Subject: FW: Comments on DEIR Ferrini Ranch

RESPONSE TO LETTER #70 – TREMPER, STEVE AND HEATHER

Monterey County Planning Department
To: Project Planner: David Mack
re: Ferrini Ranch Subdivision DEIR
Planning File Number: PLN040758
Toro Area Plan
Via email: MackD@co.monterey.ca.us
From: Mike Weaver, Chair
The Highway 68 Coalition
(831) 484-6659

RESPONSE TO LETTER #73A – WEAVER, MIKE

EXHIBIT "A-2"

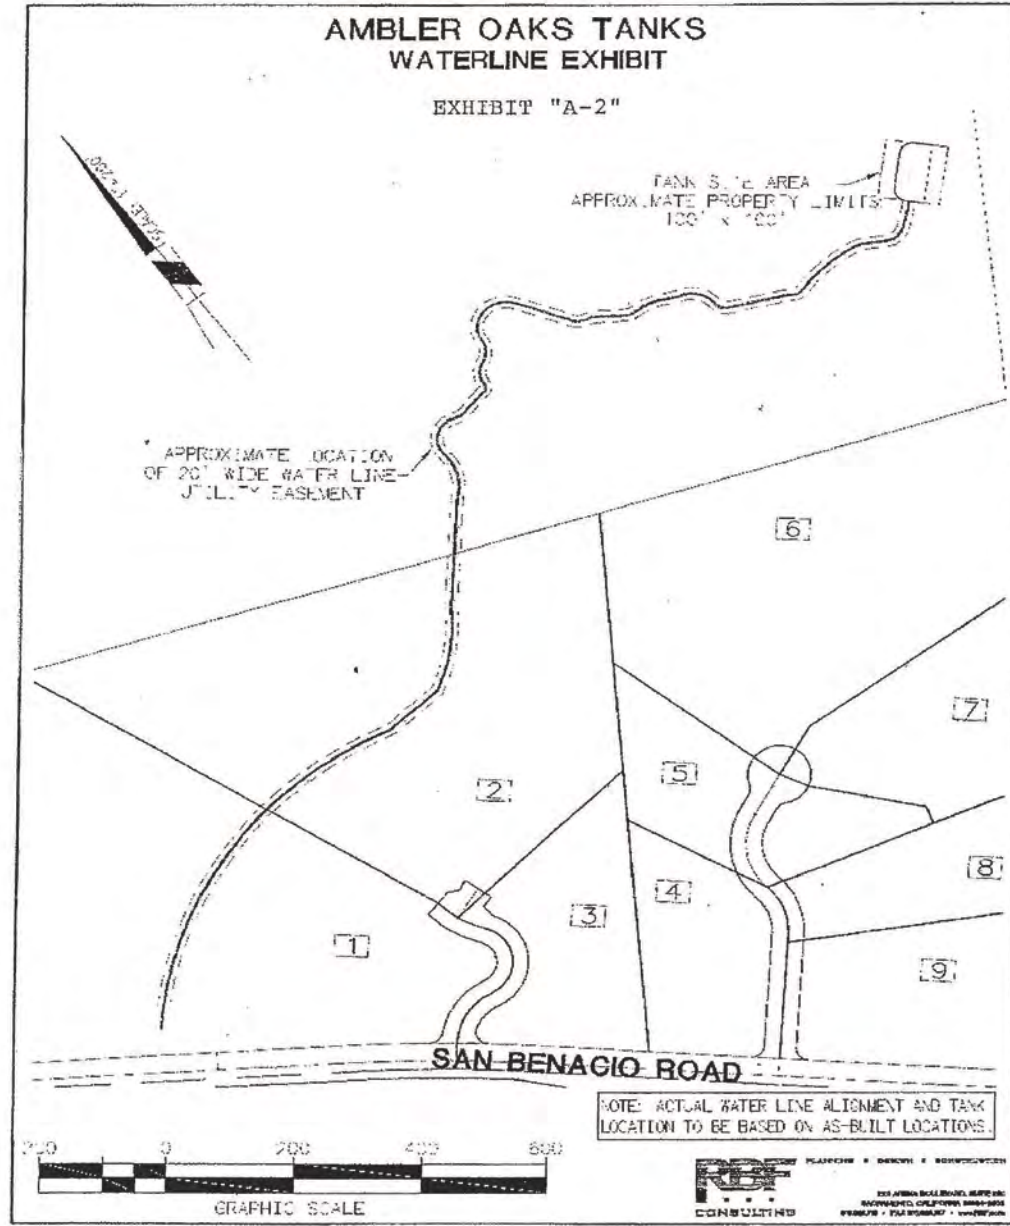
* In this attachment, Exhibit A-2 diagram shows the plan.

b) Might this call into question just what is the intended source of water for at least the western portion of the Ferrini Ranch project?

Comments refer to circumstances associated with an adjacent project. Comments are noted for the record. Please see Response to Comment 73b-2 regarding the project's water source. In the course of processing the Ferrini Ranch application, it should be noted that Cal-Am and the County of Monterey have recently executed a Memorandum of Understanding (MOU) regarding the Oaks well and treatment of water within the Ambler system.
